SERVICE PARTS LIST FOR MITSUBISHI ELECTRIC PACKAGED AIR-CONDITIONERS

Series : PLFY-P•NLMU-E

REVISED

BWE0513F

EXTERNAL PARTS

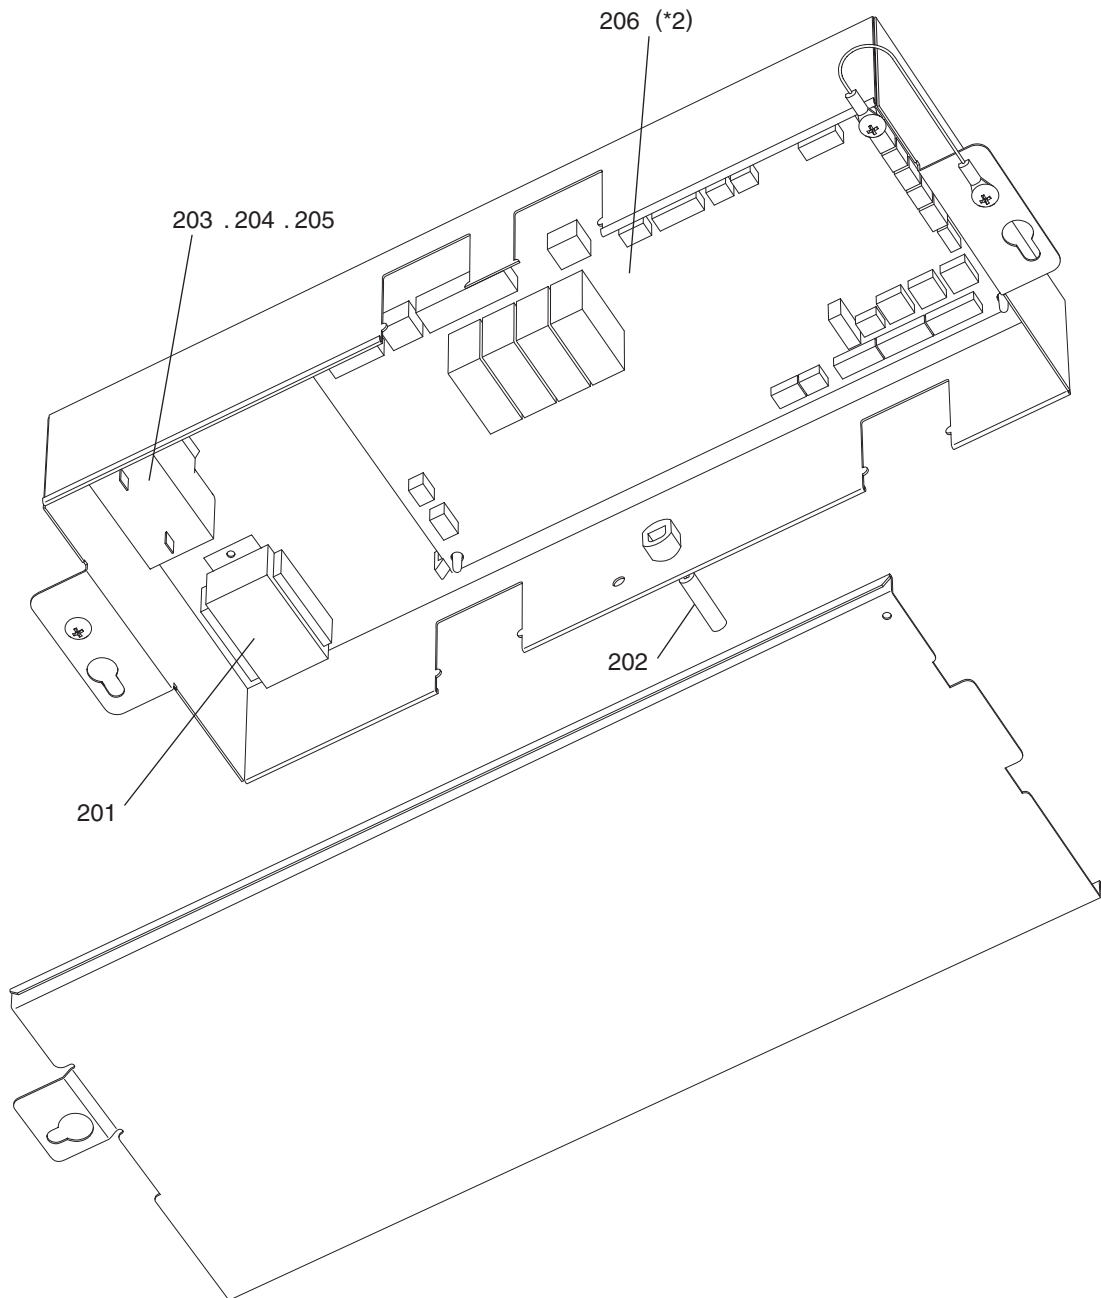
Please change the old catalog (issued Mar. 2012, BWE0513E) to this new catalog.
Content of revision : Some of parts are changed.

*1 Products manufactured in or before July 2020 have the EFM-type LEV. Products manufactured in or after Aug. 2020 have the PAM-type LEV. Replace the EFM-type LEV with the PAM-type LEV, using parts 106 and 130.

*2 For the products whose serial number is 24W***** or later, be sure to use No. 207.
 For the products whose serial number is 13W***** or earlier, both No. 206 and 207 can be used.
 No. 206 will be supplied as long as the stock is available,
 and only No. 207 will be supplied after the existing stock of No. 206 is depleted.
